# CITY OF ALBUQUERQUE

**Re: Santa Barbara Multigeneration Center**  
**1825 Edith Blvd. NE**  
**30-Day Temporary Certificate of Occupancy**  
**Transportation Development Final Inspection**  
Engineer's Stamp dated 05-26-23 (H15-D070)  
Certification dated 06-06-24

RE: SBMT Multigenerational Center, 1825 Edith Blvd NE  
Traffic Circulation Layout Certification (H15/D070)

SITE PLAN

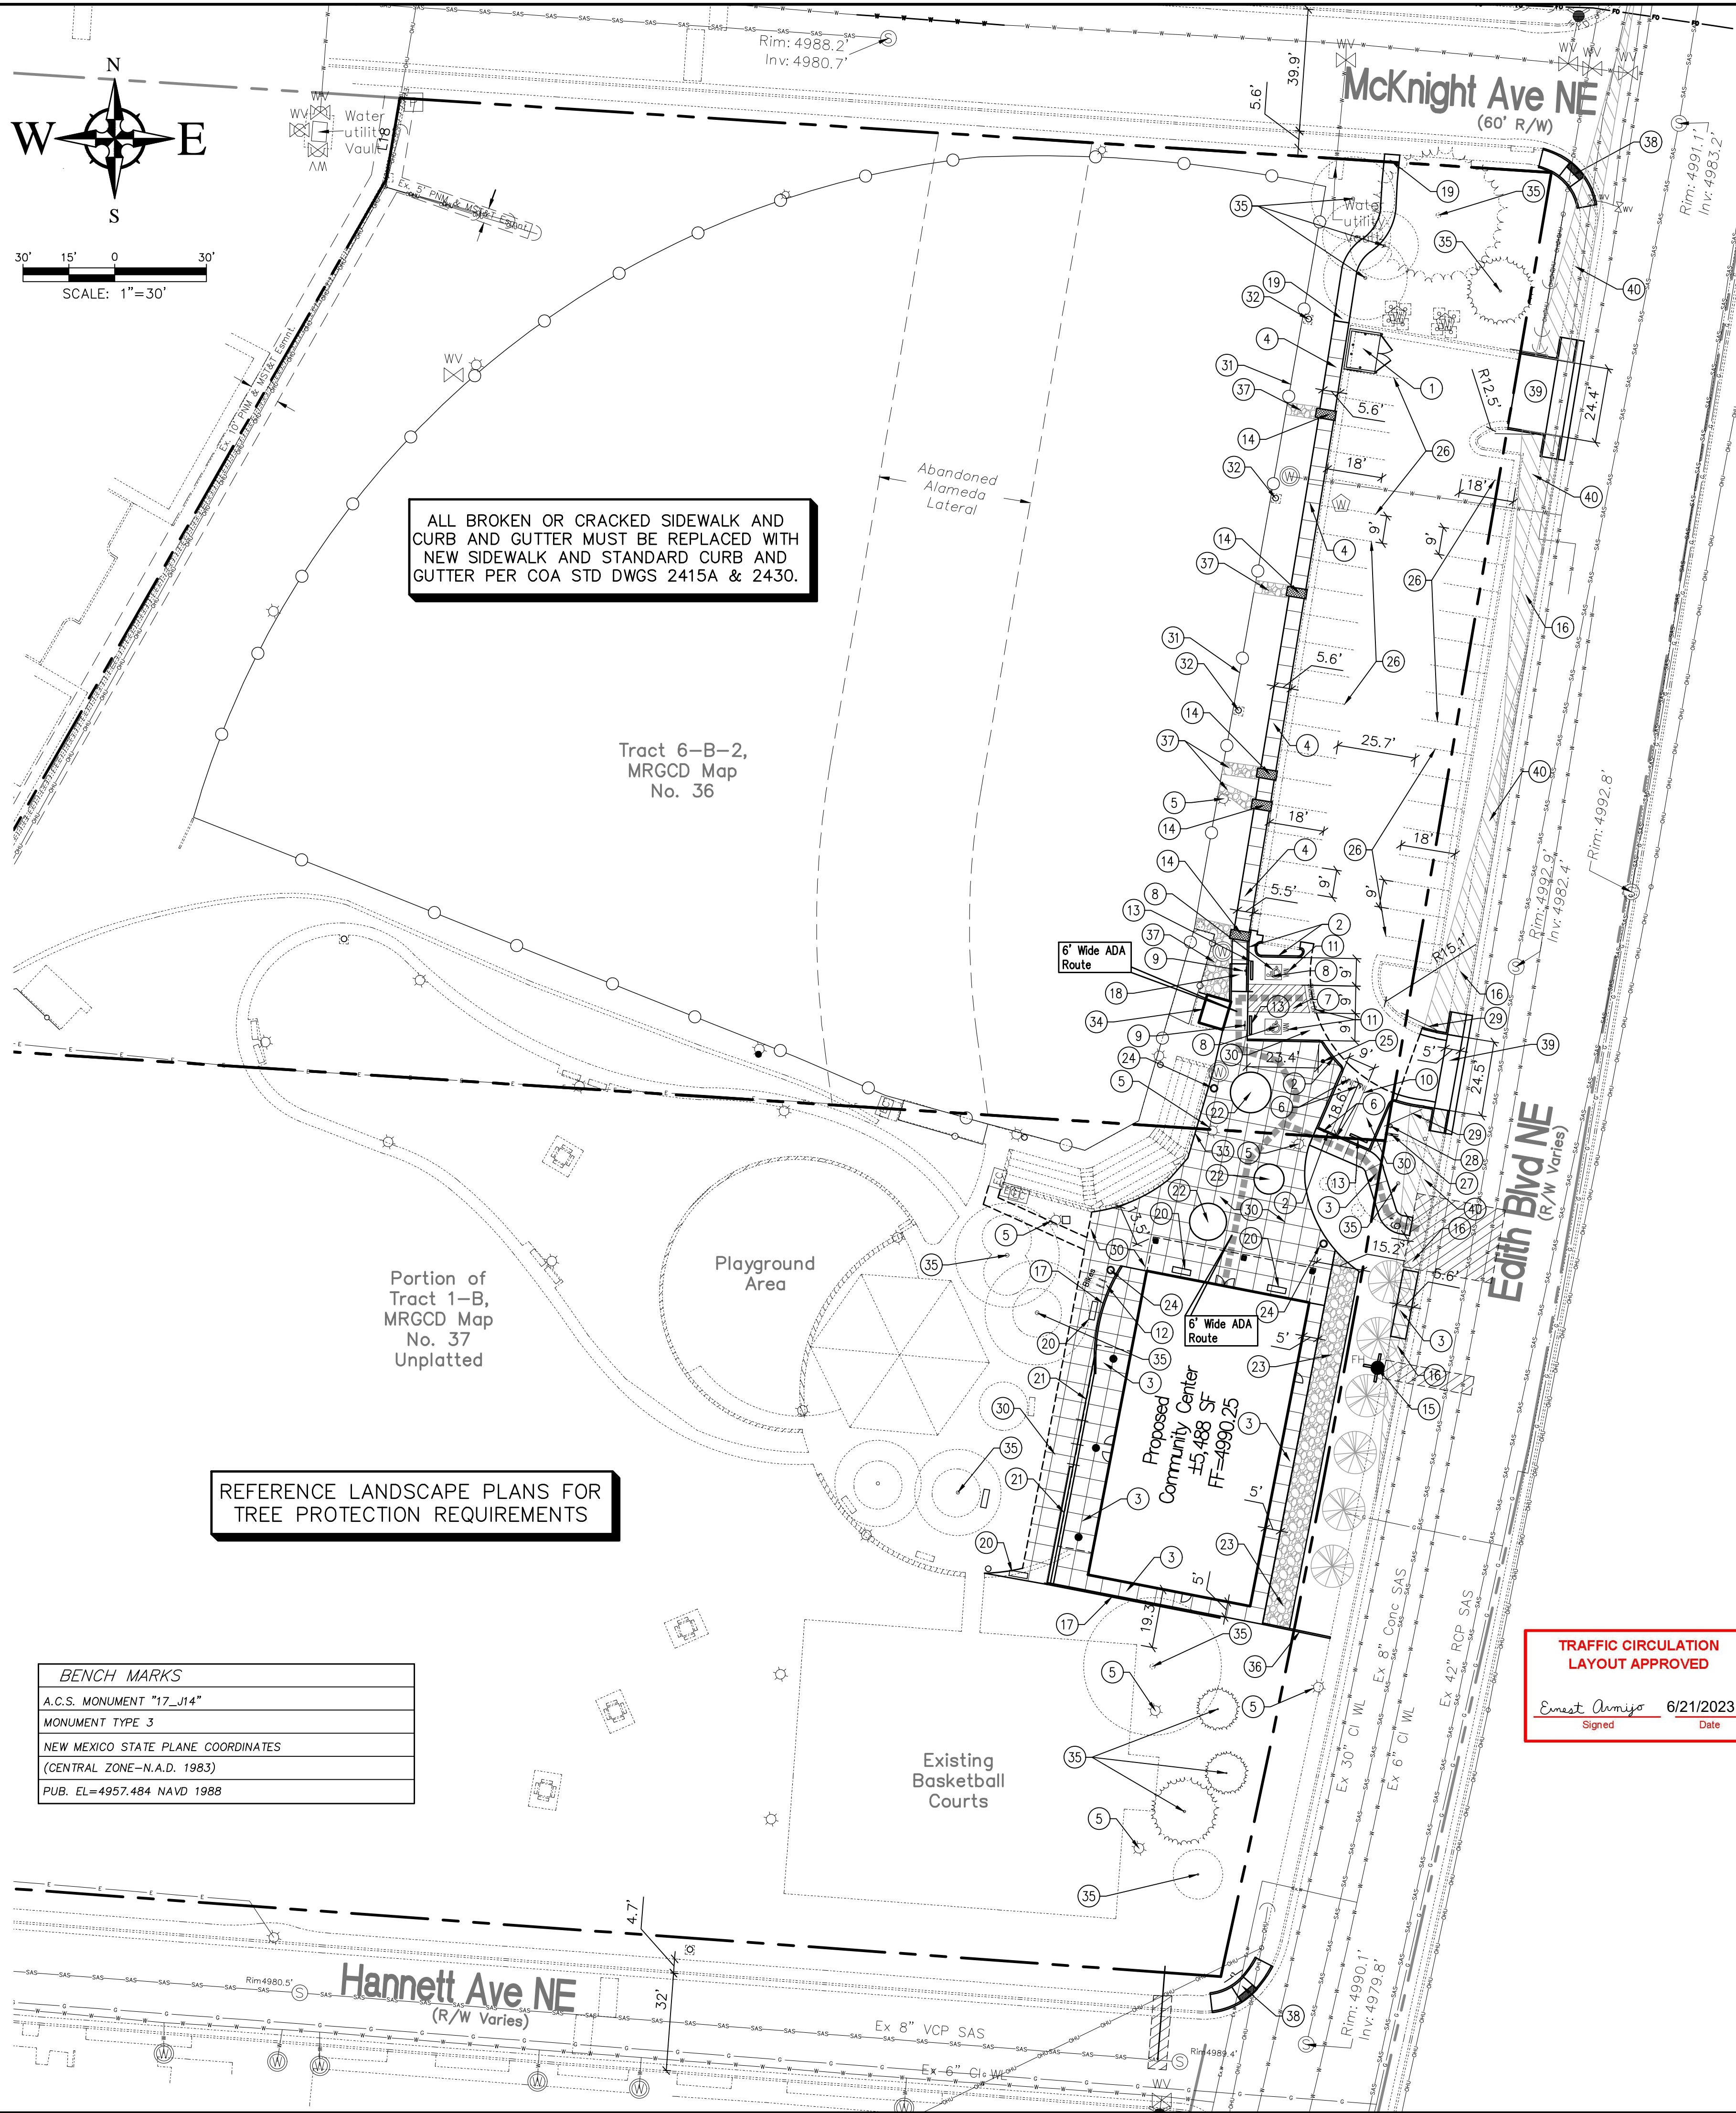
- Provide Motorcycle parking sign.
- Based on the site visit, the cross slope of the south site access off Edith is 3.8%, while ADA requirements specify the slope should not exceed 2% in all direction. This site access should be upgrade to meet the current ADA standard.

Once these corrections are complete, email pictures to [malnajira@cabq.gov](mailto:malnajira@cabq.gov) for release of Final CO.
